SHOAL CREEK ADDITION WICHITA, SEDGWICK COUNTY, KANSAS

RE: SUB 2000-22 -- Final Plat of SHOAL CREEK ADDITION (FORMERLY WHITEWOOD ADDITION)

At the regular meeting of the Subdivision Committee of the Metropolitan Area Planning Commission on Thursday, September 14, 2000, the above captioned plat was considered. The action of the Committee was to approve the final plat, subject to the following:

CASE NUMBER: SUB 2000-22 --SHOAL CREEK ADDITION (formerly Whitewood Addition)

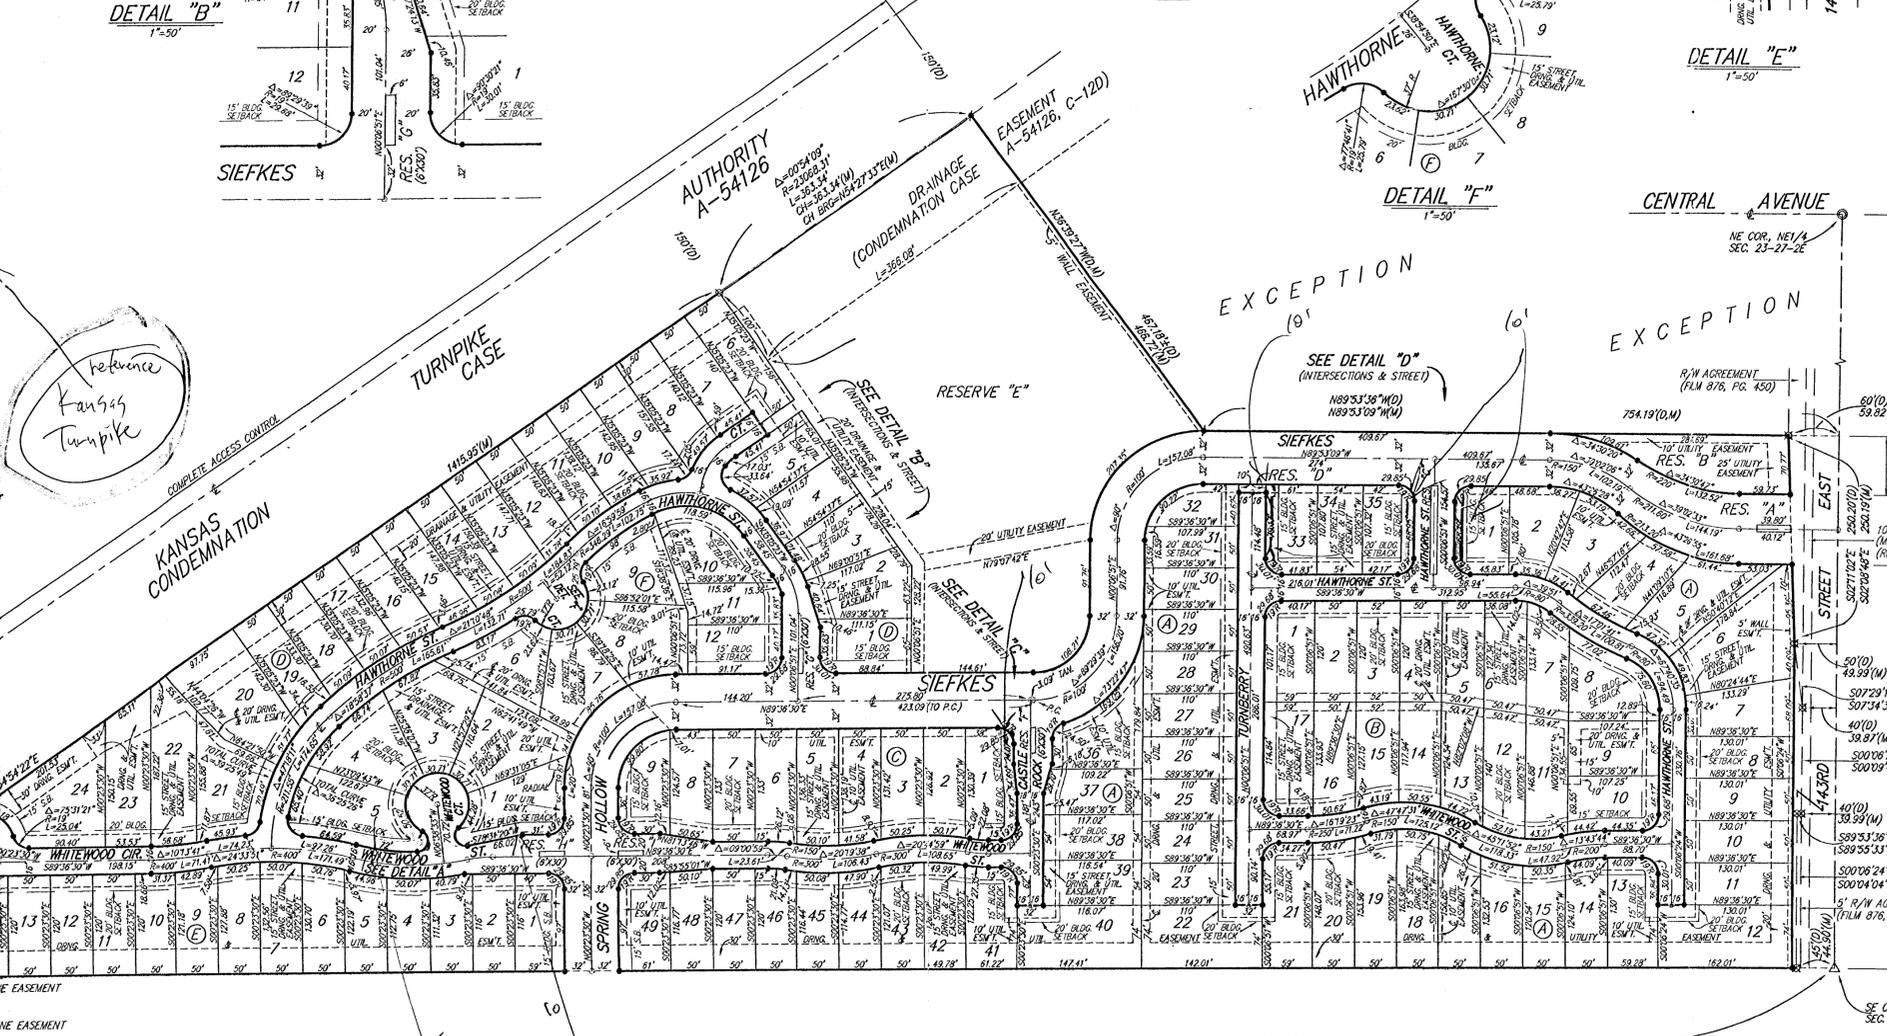
- A. In order to allow for the lot sizes being platted, and since the plat is adjacent to the City of Wichita, the applicant shall request annexation into the City. Upon annexation, the property will be zoned SF-6, Single-Family residential and permit the lot sizes being proposed. The final plat shall not be scheduled for City Council consideration until annexation has occurred.

- B. The applicant shall guarantee the extension of sanitary sewer to serve the lots being platted. This guarantee shall be with the County for service through the Four Mile Creek sanitary sewer system. On the final plat tracing, appropriate wording shall be added to the Mayor's signature block indicating the City's agreement to allow a County sewer district to be formed within the City. *A revised sanitary sewer/utility layout is requested. Off-site sewer easements are required.*

- E. *City/County Engineering* needs to comment on the status of the applicant's drainage plan. *A drainage guarantee is required. As drainage from the site is directed onto the Kansas Turnpike, a letter shall be required from KDOT indicating their agreement to accept such drainage.*

- F. Complete access control is required along the Kansas Turnpike. The dedication of access controls shall be referenced in the plat's text on the final plat.

- G. City Fire Department needs to comment on the 2,400-ft cul-de-sac (Siefkes/Whitewood Court) which exceeds the 1,200 maximum length standard of the Subdivision regulations. City Fire Department requests an emergency access easement to provide two points of access along Reserve D, Block A.

- K. The MAPC Policy Statement regarding Cluster Development states that each open space area shall be a minimum of 10,000 square feet and that no lot reduced in area shall be more than 500 feet from the nearest open space area. Lots 36-39, Block E are not located within the required 500 feet from Reserve E. A modification from this design standard has been approved.

- M. The lots in Block E shall be renumbered beginning with Lot 1.
- N. The terminus of Whitewood Court to the west shall be reconfigured as a circular turnaround.

- O. Traffic Engineering needs to comment on the need for improvements to 143rd St. East. Traffic Engineering has required the construction of a decel lane.

- Q. The pipeline easement on Lot 26, Block E, needs to be located.
- R. A dimension needs to be added on Lots 5 and 6, Block D.

- S. Since this plat proposes the platting of narrow street right-of-way with adjacent "15-foot street drainage and utility easements", a restrictive covenant shall be submitted which calls out restrictions for lot-owner use of these easements. Retaining walls and change of grade shall be prohibited within these easements as well as fences, earth berms and mass plantings.

- T. **City Fire Department** needs to comment on the plat's street names. **The City Fire Department has met with the Applicant to revise the street names.**

- U. The applicant shall guarantee the installation of the interior streets. This guarantee shall include a sidewalk along one side of Whitewood/Siefkes. **In lieu of sidewalks on Siefkes Court and Whitewood Place/Whitewood Court, the Applicant has agreed to submit an alternate sidewalk plan denoting sidewalks around Reserve E.**

- V. The applicant shall submit a covenant which provides for four (4) off-street parking spaces per dwelling unit on each lot which abuts a 32-foot street. The covenant shall inventory the affected lots by lot and block number and shall state that the covenant runs with the land and is binding on future owners and assigns.

- DD. Perimeter closure computations shall be submitted with the final plat tracing.
- EE. Recording of the plat within thirty (30) days after approval by the City Council and/or County Commission.
- FF. The representatives from the utility companies should be prepared to comment on the need for any additional utility easements to be platted on this property. **KGE has requested additional utility easements.**
- GG. The applicant is reminded that a disk shall be submitted with the final plat tracing to the Planning Department detailing this plat in digital format in AutoCAD. This will be used by the City and County GIS Department.
- HH. **The MAPC Chairman needs to be revised to reference, "Jerry Michaelis".**
